Manuscript AIS 3400076: revision workbook

Every editor and reviewer comment, exact edits in LaTeX, and the response letter

Built from the decision letter (22 Sep 2026), the submitted manuscript and SI, the repository code and the original datasets.

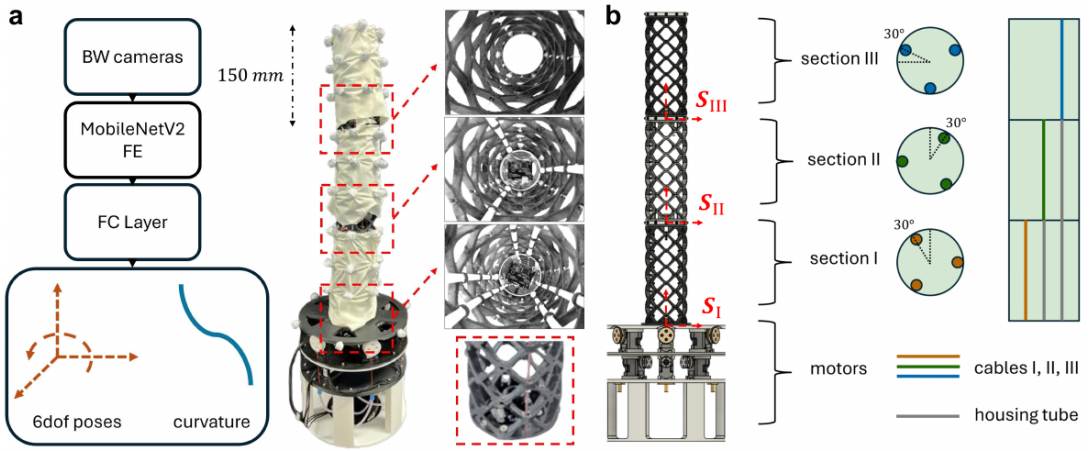
Reviewer, minor comments 12 and 15

Step 1 Manuscript, Fig. 1: replace the whole caption.

Check that S_{I}–S_{III} in Fig. 1b are the section base frames; if they denote something else, change that half-sentence.

FIGURE 2 | PCC parameterization of soft robots according to both $\alpha\,(\theta, \phi, L)$ and $q\,(\Delta_x, \Delta_y, L)$ parameters, derived from the four arc lengths $\{L_i\}_{i=1,\dots,4}$. The tendon angles $\{\delta_i\}_{i=1,\dots,3}$ and the radius d are also indicated.

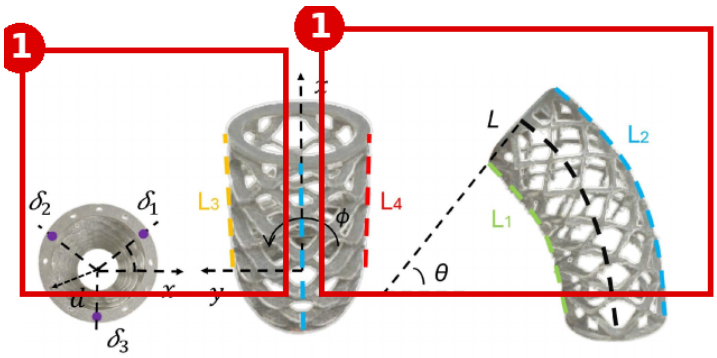
Several figures—particularly Figs. 1B, 2, 3, and 5—are difficult to interpret. [...] In particular, Figure 3 requires attention. [...] The paper should use a consistent flow direction, label all network inputs and outputs, and distinguish clearly between the networks used for pose estimation, curvature reconstruction, forward kinematics, and inverse kinematics.

Step 2 **Manuscript, Fig. 2: replace the whole caption.**

```
\caption{PCC parameterization of soft robots according to both $\boldsymbol{\xi}(\theta, \phi, L)$ and
$\mathbf{q}(\Delta_x, \Delta_y, L)$ parameters, derived from the four arc lengths $\{L_i\}_{i=1,\dots,4}$.
$L_1$--$L_4$ are the arcs at distance $d$ from the central axis along the $\pm x$ and $\pm y$ directions that
define $\Delta_x$ and $\Delta_y$ (Eq.~S1); they are geometric constructions, not tendons. The three tendons are
placed at the angles $\{\delta_i\}_{i=1,\dots,3}$ on the circle of radius $d$.}
```

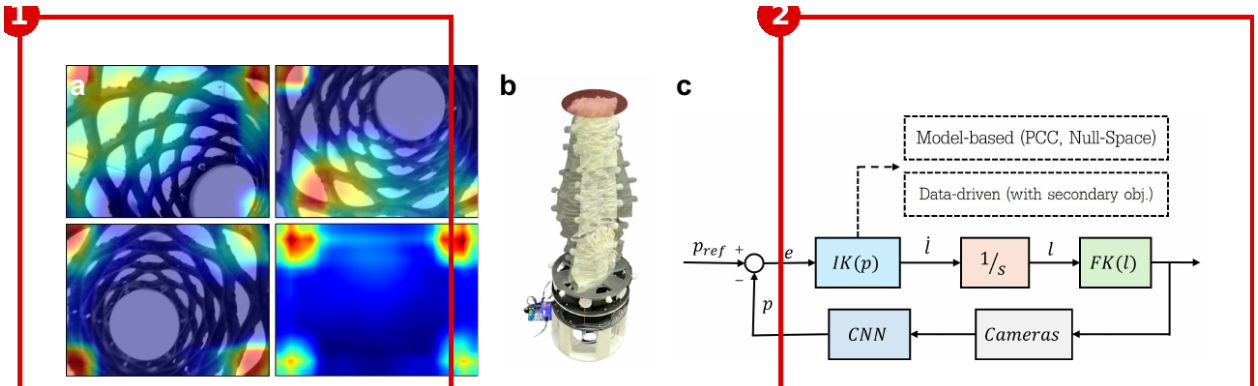
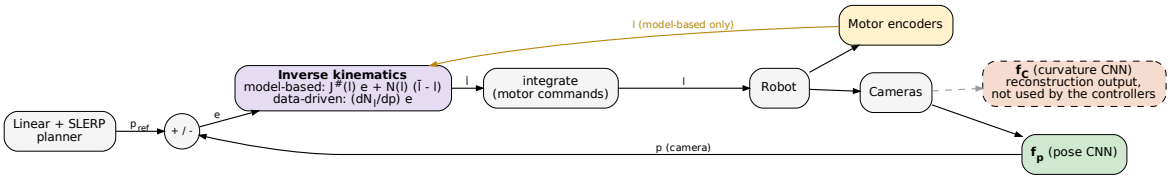
Reviewer, Comment 1 (excerpt) and minor comment 17

The abstract, contribution list, Fig. 4c, and conclusion should clearly distinguish: camera-based pose estimation used for control; encoder measurements used to calculate the Jacobian and null-space term; and image-based PPC reconstruction evaluated as a separate sensing capability. [. . .] clarify how the highlighted pixels are the regions used for prediction.

Step 5 **Manuscript, Fig. 4c: add one block and one arrow (marker ②).**

Add a block “Encoders” that reads $\mathbf{l}$ (the output of the $1/s$ block). Draw an arrow from it to the box “Model-based (PCC, Null-Space)” and label it “$\mathbf{l}$ (model-based only)”. Optionally, add a dashed block “f_C (curvature CNN): reconstruction output, not in the loop”, fed by “Cameras”. Sketch:

Step 6 Manuscript, Fig. 4: replace the whole caption (covers 4a and 4c).

```
\caption{(a) Grad-CAM visualizations from $f_p^1$ for different bending configurations and average Grad-CAM over
the test set. Colors show the heatmap of Eq.~S12, normalized to $[0, 1]$ per image and displayed without
thresholding; warm colors mark the regions whose activation most reduces the prediction loss. The network mostly
focuses on deformations of the Trimmed Helicoid structure along the bending direction. (b) Different null-space
configurations yield the same tip pose. (c) High-level kinematic closed-loop controller. The tip pose estimated
by the pose CNN from the camera images is the feedback signal of both controllers. In the model-based controller,
the motor encoders provide the tendon lengths used by the PCC Jacobian and the null-space term; the data-driven
controller does not use encoders. The curvature CNNs are not part of the control loop.}
```

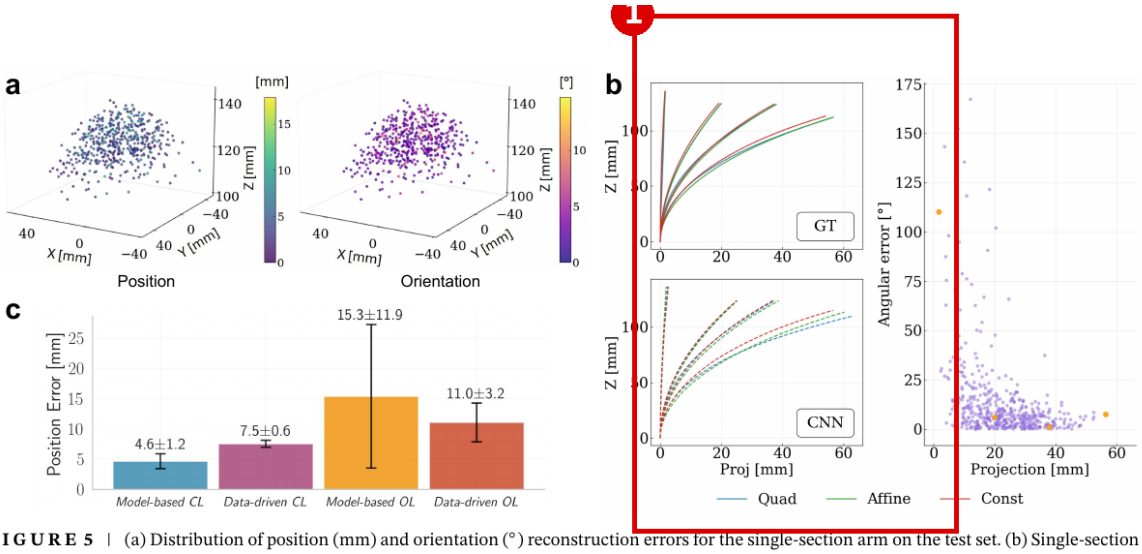
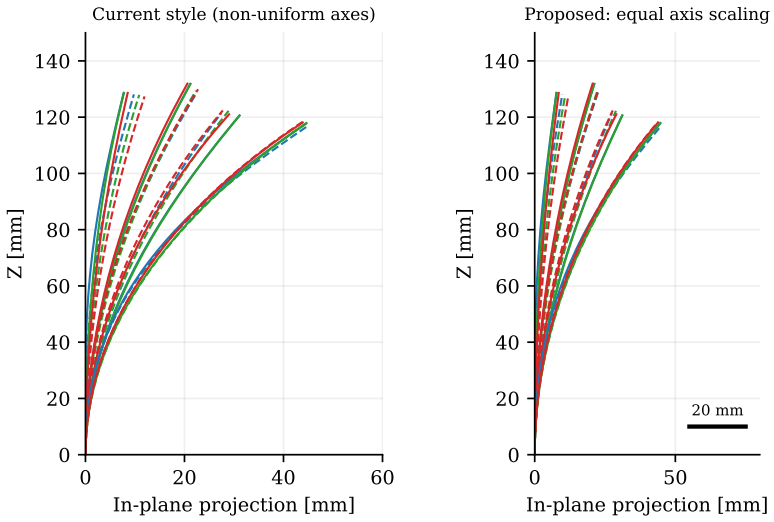
Reviewer, minor comment 22

Figure 5b intentionally uses nonuniform axis scaling. This visually distorts the reconstructed shapes. Use equal spatial scaling where possible or add a second undistorted view and explicit scale bars.

Step 7 Manuscript, Fig. 5b: equal axis scaling (marker ①).

In the plotting code of the two shape panels (GT and CNN), set `ax.set_aspect('equal')` and give both panels the same limits (e.g. x 0–60 mm, z 0–150 mm). Equal axes make the panels narrow, so the simplest layout is one panel with GT (solid) and CNN (dashed) overlaid. The right panel below shows this layout, produced from the same models (`SINGLE/results/fig5b_equal_axes.pdf`, from `SINGLE_revision_figures.ipynb`):

Step 8 **Manuscript, Fig. 5: replace the whole caption.**

```
\caption{(a) Distribution of position (mm) and orientation ($^\circ$) reconstruction errors for the
single-section arm on the test set. (b) Single-section curvature reconstruction and bending angle error. Four
test examples with increasing deformation are shown, with GT (ground-truth) reconstructions as solid and CNN
predictions as dashed lines. Axes have equal scaling. The corresponding $\phi$ angular errors are highlighted in
orange. (c) Performance of the proposed controllers on the control workspace of the single-section arm (CL:
closed-loop; OL: open-loop). Bars show the mean final position error over the 20 targets; error bars show one
standard deviation across targets, each visited once.}
```

1.6 Figures 6, 9 and 10

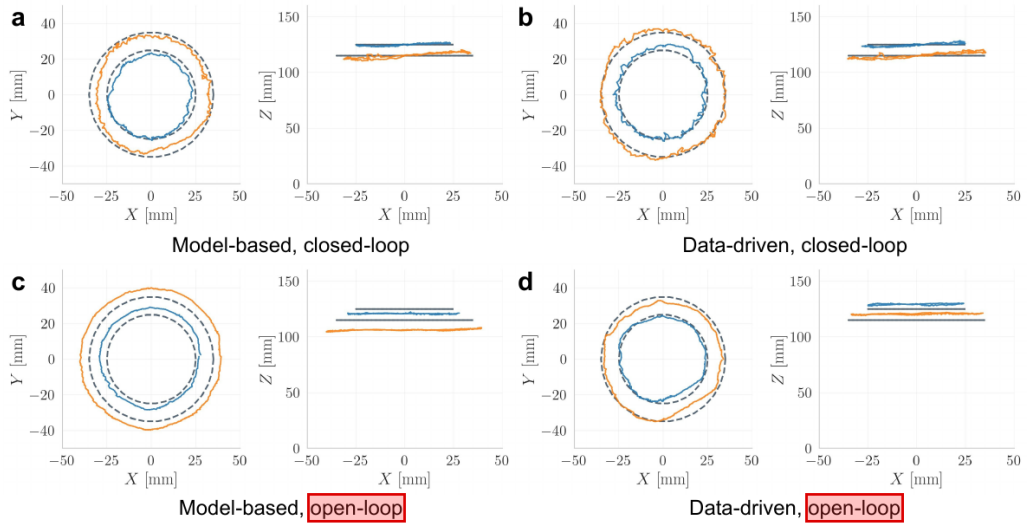
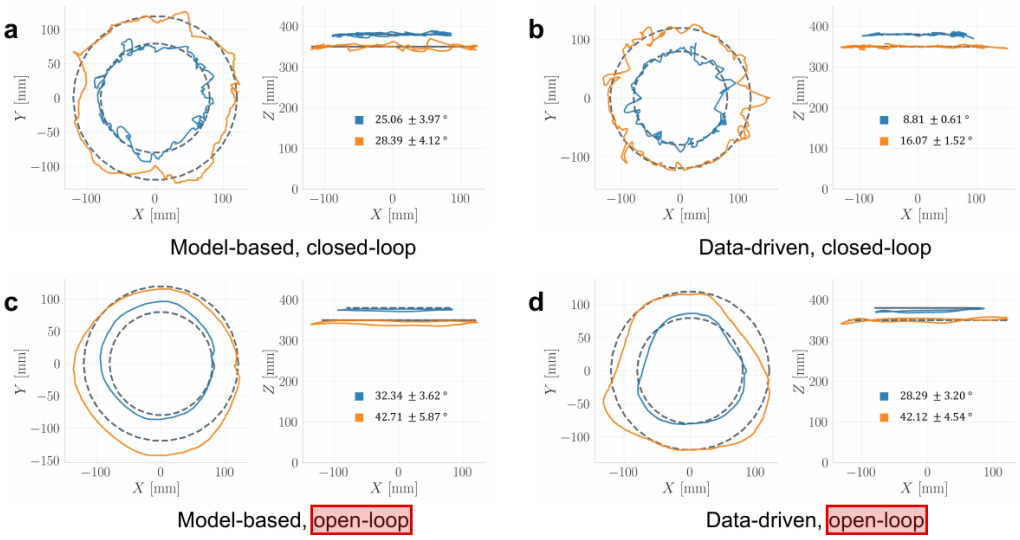
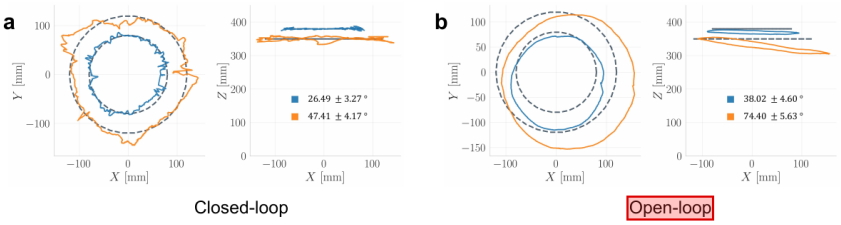
Reviewer, minor comments 20 and 26

'Open-loop' and 'feedforward' should be used consistently. [. . .] For Figs. 6, 9, and 10, identify the start direction, waypoint order, number of completed cycles, and whether the plotted paths are one run or an average. Add quantitative path errors in the caption or an accompanying table.

Step 9 Manuscript, Figs. 6, 9 and 10: replace the three captions.

Step 10 **SI, end of the document: add Table S7 (path errors, generated from the repository's `PathErrorMetrics` files).**

```
\begin{table}[h]
\centering
\caption{Path errors of the trajectory-tracking experiments (Figs.~6, 9 and 10). Radial RMS: root-mean-square distance of the executed path from the reference circle, measured in the horizontal plane; height RMS: root-mean-square of $z - z_{\mathrm{ref}}$. The reference circle is the commanded one (center and radius of the commanded waypoints). Each row is a single run of one cycle; consecutive samples along a path are serially correlated and are not independent trials.}
\label{tab:S7_paths}
\begin{tabular}{lllrrr}
\toprule
Arm & Controller & Loop & $z_{\mathrm{ref}}$ [mm] & Radial RMS [mm] & Height RMS [mm] \\
\midrule
Single & Model-based & closed & 115 & 1.46 & 2.65 \\
Single & Model-based & closed & 125 & 1.32 & 1.23 \\
Single & Data-driven & closed & 115 & 1.71 & 2.49 \\
Single & Data-driven & closed & 125 & 1.83 & 1.54 \\
Single & Model-based & open & 115 & 8.06 & 8.74 \\

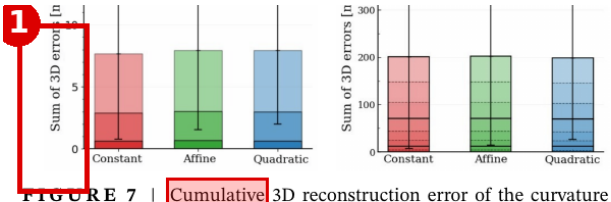
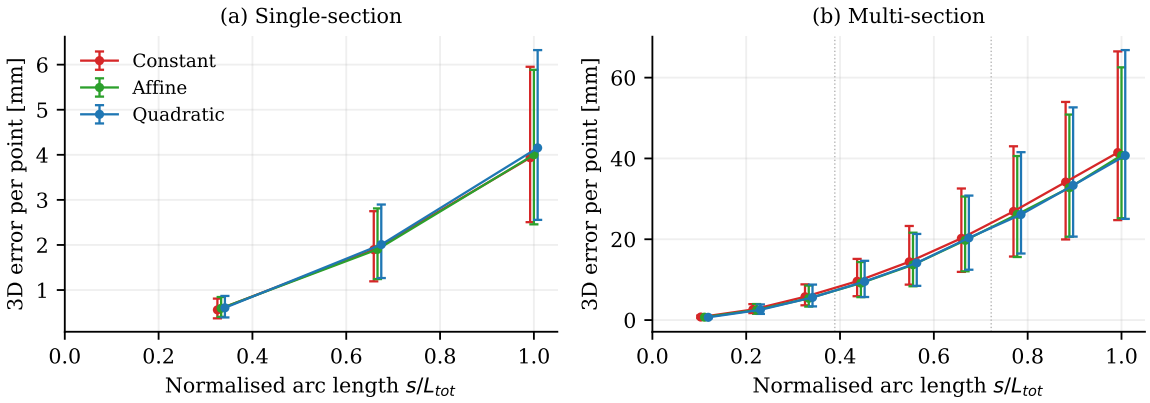
Reviewer, minor comment 23

Figure 7 alternates among 'cumulative 3D error,' 'sum of 3D errors,' and 'average 3D error for each point.' Define the statistic exactly. Summing three points for the single-section arm and nine for the multi-section arm also prevents direct comparison. Per-point RMSE or error versus normalized arc length would be clearer.

Step 11 **Manuscript, Fig. 7: replace the graphic with the per-point version.**

The new version uses the same models and the same test set. The bar heights of the current figure (7.8, 7.9, 8.3 mm and 209, 203, 198 mm) are the sums of the per-point means shown here. Use `MULTI/results/fig7_per_point.pdf` (from `MULTI_revision_figures.ipynb`) as is, or replot it in your style (median and interquartile range against s/L_{tot}):

Step 12 **Manuscript, Fig. 7: replace the whole caption.**

```
\caption{3D reconstruction error of the curvature models along the backbone. For each test sample ($N = 500$),
the backbone reconstructed from the predicted curvature parameters is compared with the one reconstructed from
the curvature labels, and the 3D distance is evaluated at each reference point. (a) Single-section arm: reference
points at $L/3$, $2L/3$, and $L$. (b) Multi-section arm: reference points every ninth of the arm length; the
labels are model-constrained (Section~2.2). The horizontal axis is the arc length normalized by the total length;
markers show the median and error bars the interquartile range.}
```

FIGURE S2 | (a) 3D reconstruction accuracy of the curvature models at reference points placed every ninth of the manipulator length. (b) Errors induced by the N_C approximation with respect to the motion-capture ground-truth.

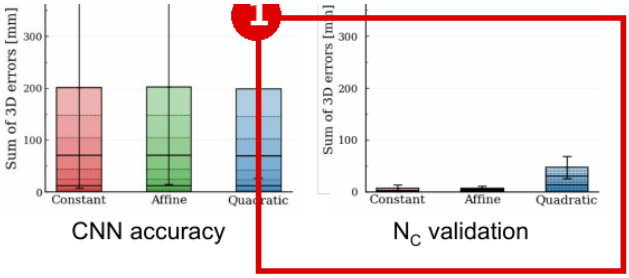
Reviewer, Comment 4 (excerpt) and SI comment 28

Fig. S2b does not provide sufficient validation of N_C: numerical errors, sample count, data split, and confidence intervals are missing. It is also unclear whether its validation configurations are independent of the data used to train N_C and the three-section curvature estimator. [. . .] Fig. S2b should report the numerical N_C error for each curvature model, the number of validation configurations, and whether the bars show standard deviation, standard error, or another interval.

Step 17 SI, Fig. S2: replace the whole caption.

```
\caption{(a) 3D reconstruction accuracy of the curvature models at reference points placed every ninth of the
manipulator length: sum over the nine points of the mean error at each point (same data as Fig.~7b). (b) Errors
induced by the $N_C$ approximation with respect to the motion-capture ground truth, on 20 configurations of the
multi-section arm posed manually with all subsection markers visible and recorded in a separate session; these
configurations were not used to train $N_C$ or the multi-section curvature CNNs. Bars show the sum over the nine
reference points of the mean 3D error at each point; error bars show one standard deviation of the
per-configuration sum across the 20 configurations.}
```

1.12 Figures S4–S6

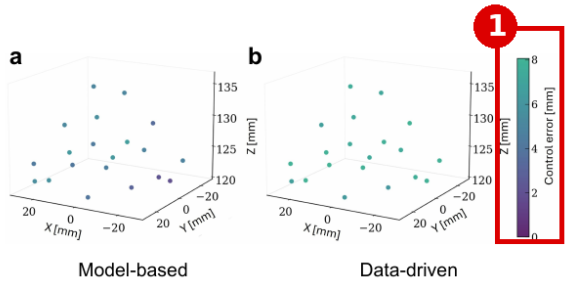
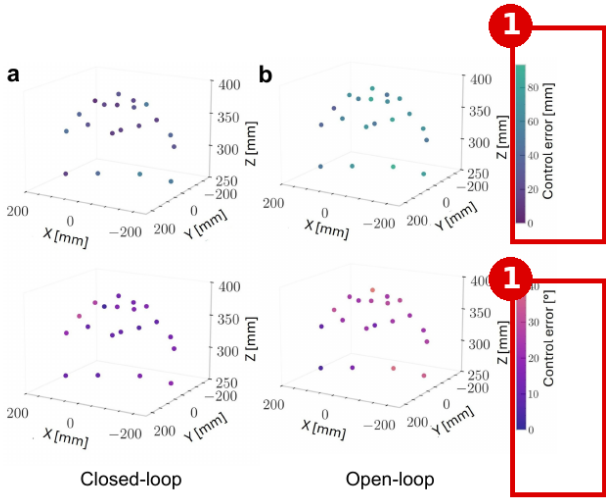
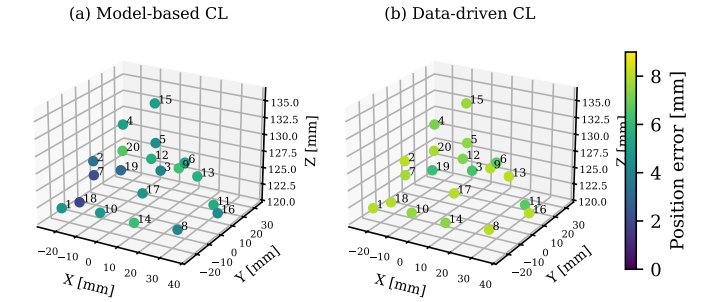
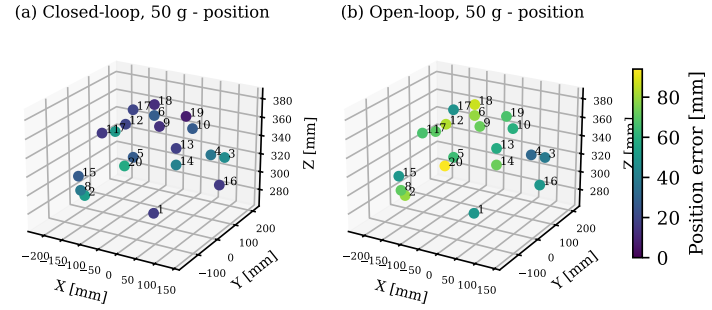
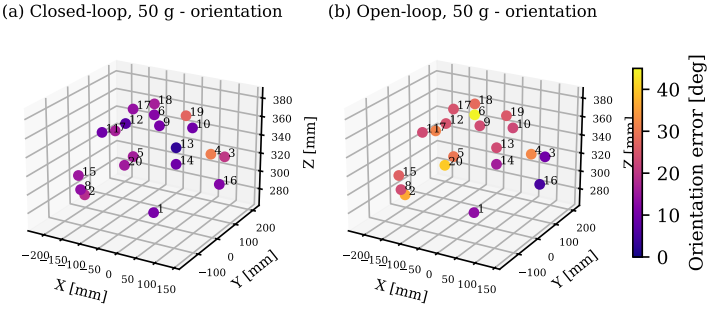
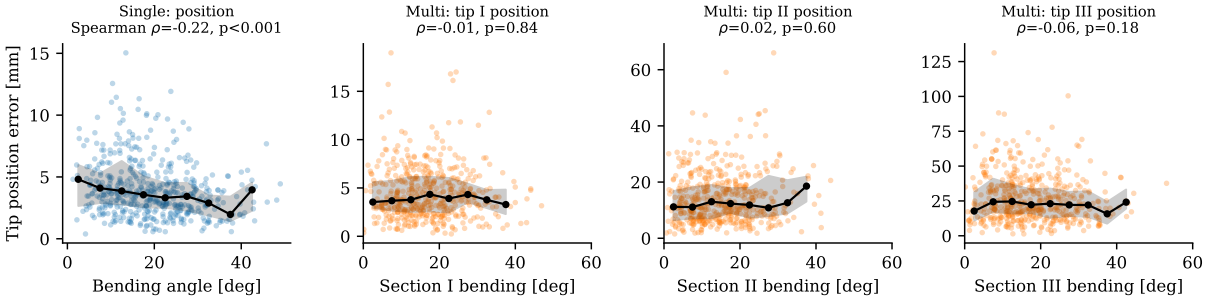
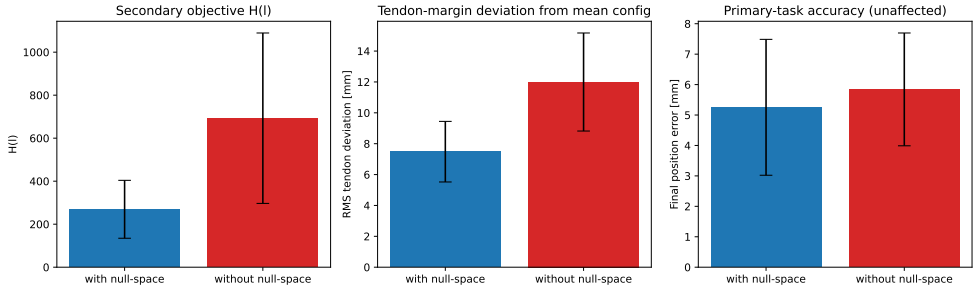
Reviewer, SI comment 30

Figs. S4–S6 should use matched target identifiers or connecting pairs so the reader can compare the same workspace locations across controllers. Use consistent color limits when the goal is direct visual comparison.

Step 19 SI, Figs. S4–S6: replace the graphics.

Same data and plots, with two changes:

- Each target carries its ID (1–20, the same as in Tables S8 and S9).
- Each figure uses one color scale per quantity; marker ① shows the current independent color bars.

Step 20 **SI, Figs. S4, S5 and S6: replace the three captions.**

```
\caption{Closed-loop tracking error distribution (mm) on the control workspace for the single-section arm. (a) Model-based. (b) Data-driven. Numbers identify the targets (Table~S8); both panels share the same color scale.}
```

```
\caption{Closed-loop tracking error distribution (mm and $^\circ$) on the control workspace for the multi-section arm. (a) Model-based. (b) Data-driven. Numbers identify the targets (Table~S9); panels showing the same quantity share the same color scale.}
```

```
\caption{Tracking error distribution (mm and $^\circ$) for the multi-section arm under external disturbance (50~g tip payload). (a) Closed-loop. (b) Open-loop. Numbers identify the targets (Table~S9); panels showing the same quantity share the same color scale.}
```
